TOLERANCE	Decimal	DATE 2018. 03. 19.		 RF & MICROWAVE TECHNOLOGY Tel : 82-32-347-8015 Fax : 82-32-347-8017
	Angle	APPROVED BY	I.C.KIM	
MATERIAL		CHECKED BY		TITLE TNC50 CABLE PS LMR240
		DRAWN BY	S.Y.EUN	
FINISH		SCALE	3/1	DWG NO. CN02192-7/3 REVISION 1 SHEET 1 of 1
		UNIT	mm

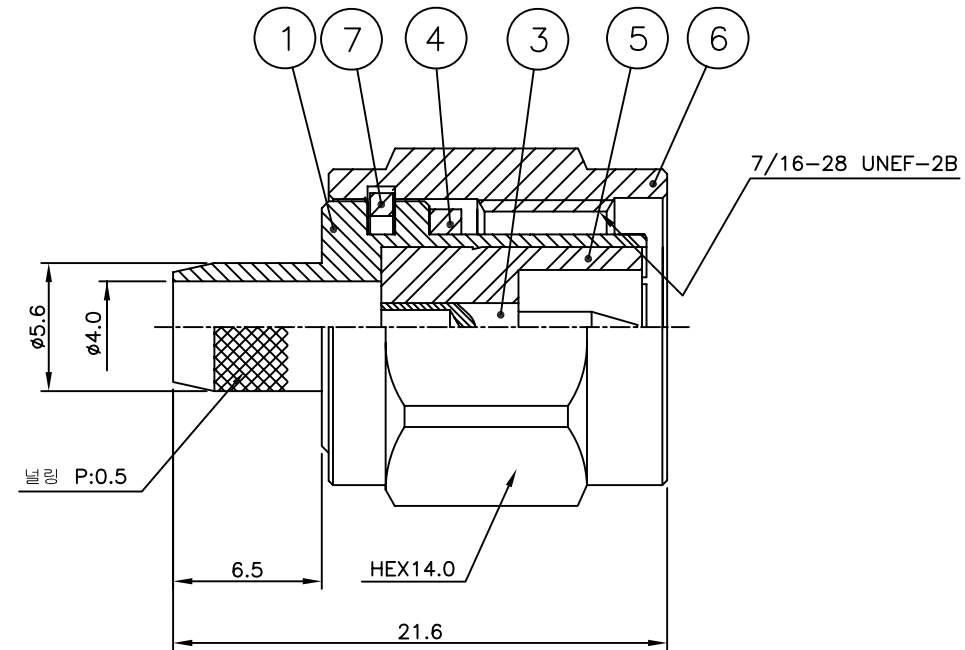
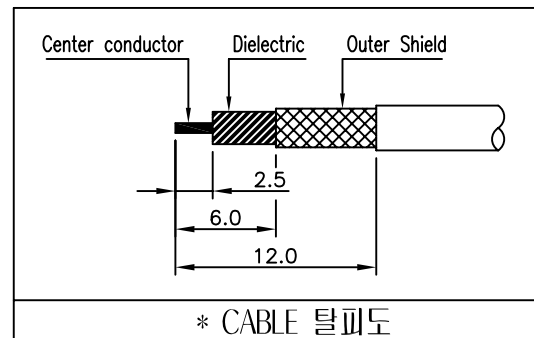
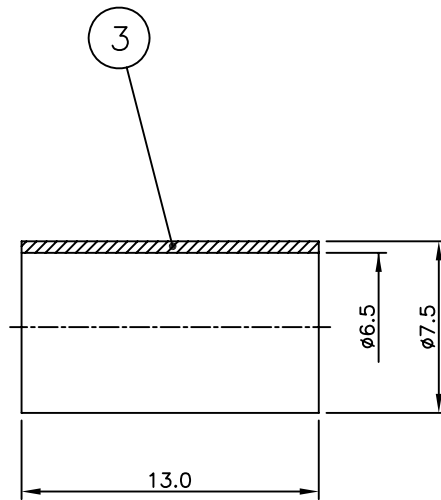
REVISION				
REV	DESCRIPTION	DRAWN	APPR	DATE
IR	Initial Registration	G.Y.KIM	I.C.KIM	2016.12.09.
1	설문처리(No.201803-0008) 상대품 체결시 가스켓 누름현상 없음-바디,캡 수정	S.Y.EUN	I.C.KIM	2018.03.19.
